APPENDIX 1A
SCOPING DOCUMENT

SCOPING REPORT FOR THE LONG CANYON MINE PROJECT ENVIRONMENTAL IMPACT STATEMENT

JBR Project Number B.A12266.00

October 19, 2012
Revised: August 23, 2013

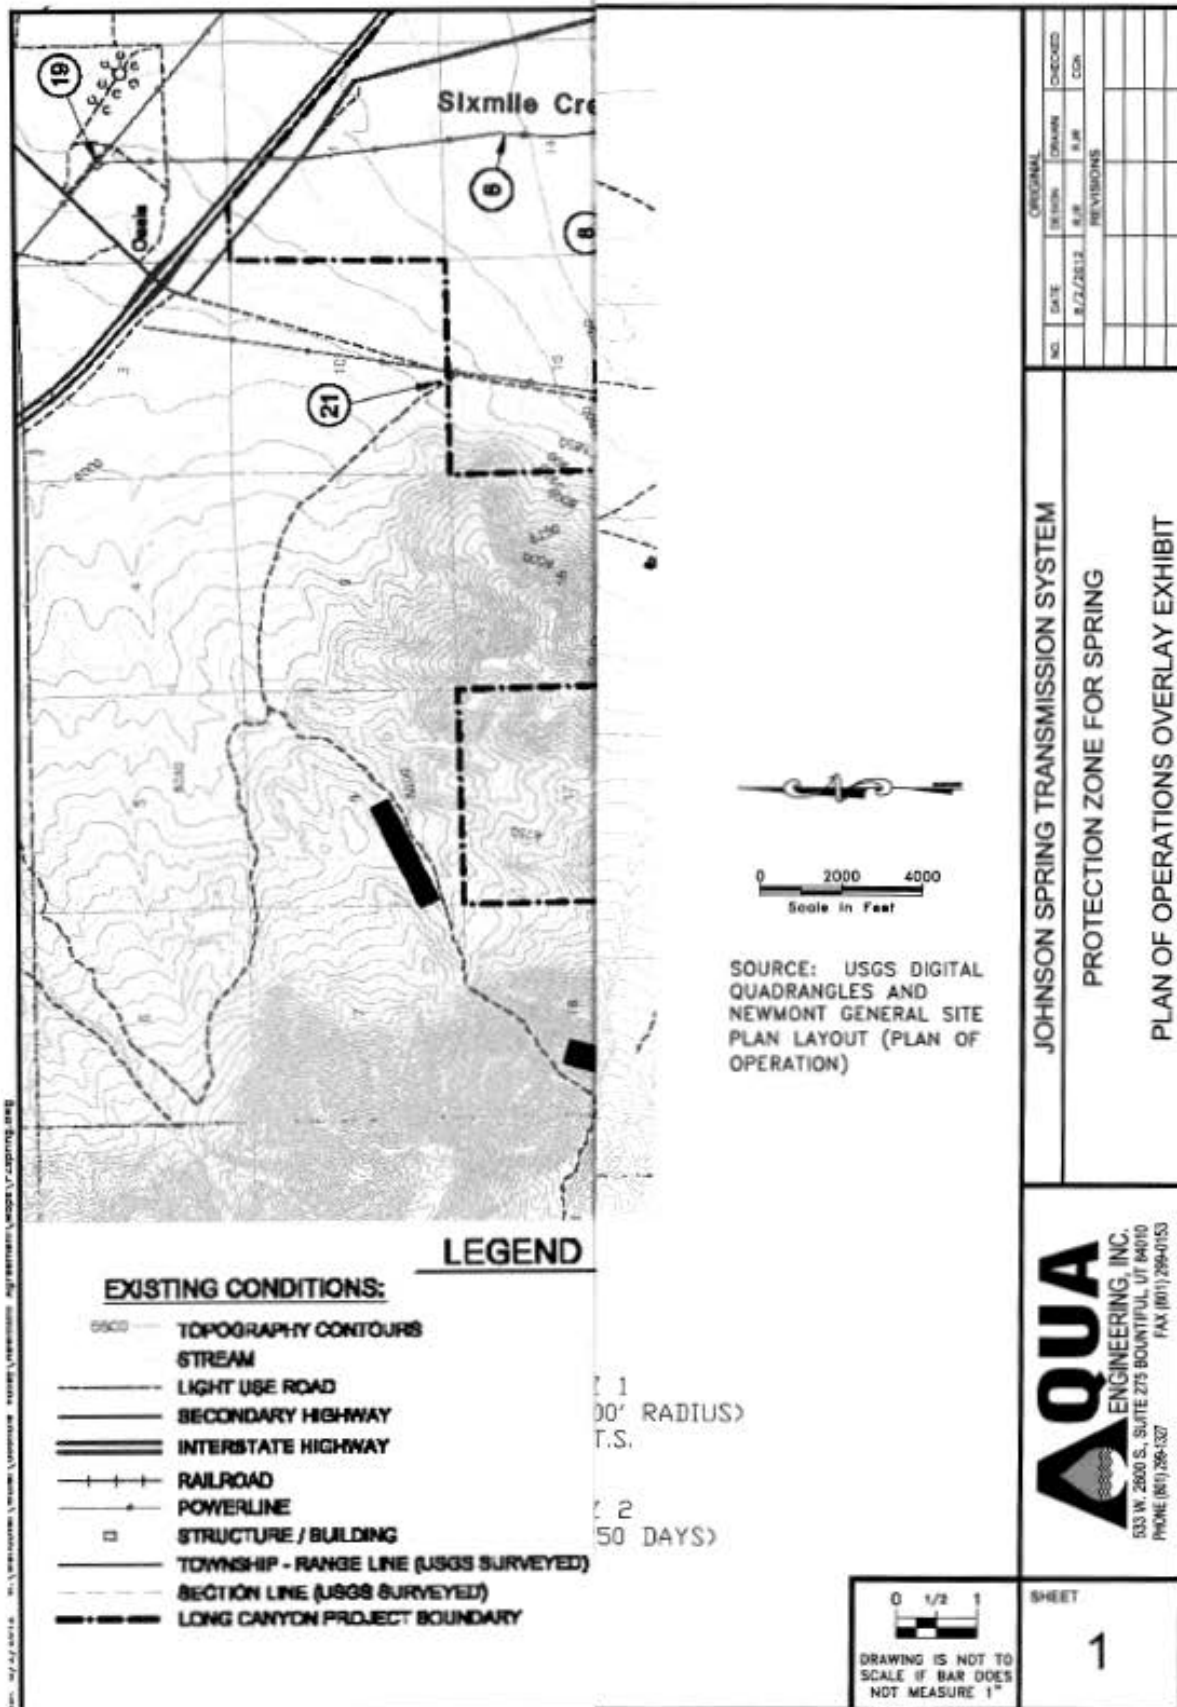
Open Pit Mine: Applicant proposes to develop the pit to an elevation of 5700 feet above mean sea level (AMSL) which is only approximately 15 feet above the top of the water table in the bedrock aquifer supplying water to Johnson Spring. Maintaining sufficient vertical separation between the static water level in the bedrock aquifer and the bottom of the pit is essential to protect the spring. The applicant's mapping shows that the bedrock in the project area of the Pequop Range is highly faulted and fractured (Figure 3-5, Golder and Associates, 2012). The results of an aquifer test conducted in 2011 by Frontier Development USA on a well located one mile north of Johnson Spring completed in the carbonate aquifer not only showed that groundwater flow is highly fracture controlled, but that there is significant interconnection of the fracture system above Johnson Spring with locally very high transmissivities along the fractures in these carbonate units surrounding Johnson Spring.

The Cities recommend a minimum vertical separation of 200 feet. This would place the bottom of the pit at elevation 5900 MSL and provide a buffer between the highly disruptive mining activities proposed in the PoO and the bedrock aquifer.

Project Facilities within and near PZ2: The Cities understand the ore body is a natural feature that dictates the location of the proposed open pit mine. However, there is no reason for the applicant to locate other project facilities within PZ2. In fact, based on the applicant's own hydrogeologic data, groundwater flow in the bedrock aquifer converges from the north, south and west to Johnson Spring which is a major point of groundwater discharge from the bedrock aquifer for this portion of the Pequop Range (Figure 4-11, Golder and Associates, 2012). Thus, even the cyanide heap leach facility, stockpile areas, and landfills should be located east of the bedrock aquifer in the alluvial fill, not within the capture zone of the spring. The Cities

Project Groundwater Diversions: The applicant's PoO plans for the water supply for the mine and milling operations to be provided from a water well completed in the alluvial aquifer. The applicant proposes a water supply well to be located approximately one mile south-southeast of Johnson Spring, and anticipates that the mine will require an operation pumping rate of 2,000 gpm from this well with periods of demand requiring up to 2,500 gpm to supply the needs of the mining operation. The Cities are extremely concerned with the impact pumping the volume of water required from a well at this location will have on Johnson Spring. This concern is validated by the results of a report prepared by Golder Associates (2012) for the applicant in which the effect of pumping at the proposed well site was simulated.
